# System Protection and Control Subcommittee

February 17, 2016 | 8:00 a.m. – 5:00 p.m. CT

# Unit Auxiliary Transformer Overcurrent Relay Loadability During a Transmission Depressed Voltage Condition

NERC System Protection and Control Subcommittee

Figure 1: Station Service Transformer Connection

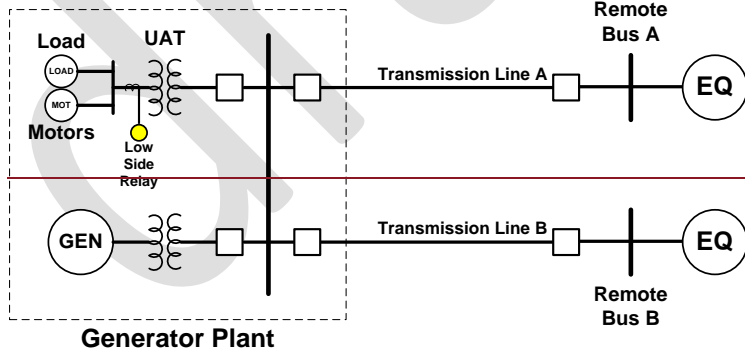
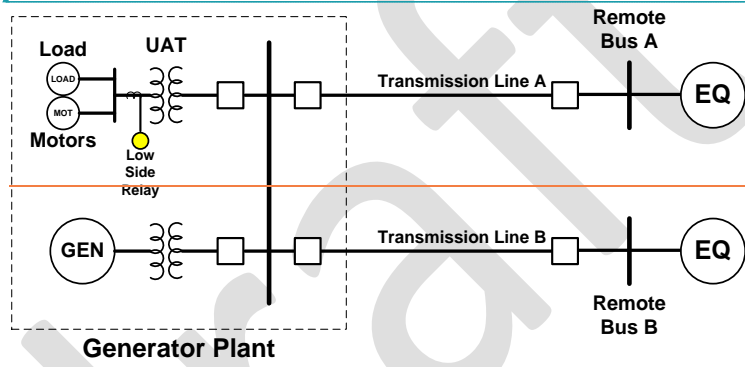
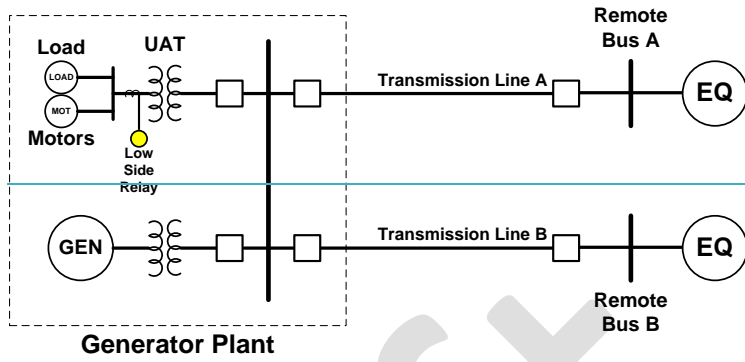
**Commented [CT26]:** I think we mean we will study the potential change in load current during depressed system voltages. The relay functions we are discussing are generally not sensitive to voltage.

**Commented [CT28]:** I believe we strictly mean induction motors. Furthermore, we probably need to differentiate between standard directly connected induction motors and those driven by adjustable frequency drives – these are becoming extremely common, often have their own voltage and frequency protection, and vary with voltage differently depending on the type.

**Commented [WPB27]:** Ok with this pbw

**Commented [WPB29]:** Need help here pbw

Figure 2: Effects of Voltage Variation on a Motor

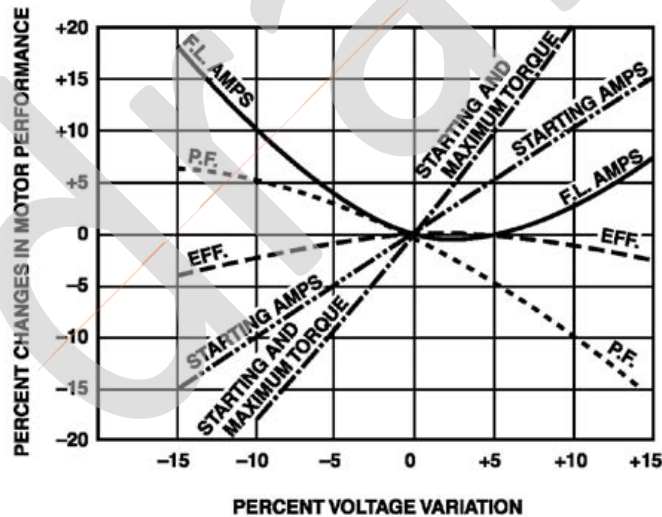
Commented [CT35]: kVA is only constant over a small band. While the current does go up, the kVA is not a constant at 0.85 pu (power factor is at plus 6% and efficiency is at minus 4%). Constant kVA is a convenient assumption for powerflow studies but is not strictly true, as shown by the curve in this chart.

Commented [CT38]: This assumes a specific motor type- B? I don't have this reference document. I agree the curves are generally a good representation of what "typically" occurs, but we are attempting to bound the majority of possibilities...do we need to consider the variations due to differences in motor designs? A type D for example will behave quite differently, to my understanding.

Figure 4: UAT Connection used in PRC-025 Standard Drafting Team Study

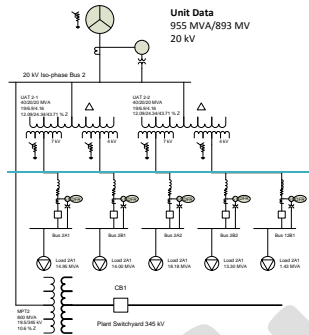
Commented [HS56]: What if there is a cap bank, Statcom nearby on the transmission system

Commented [CT57]: Is this “study” referring to the Guidelines and Technical Basis that were posted with PRC-025-1 during the development process?
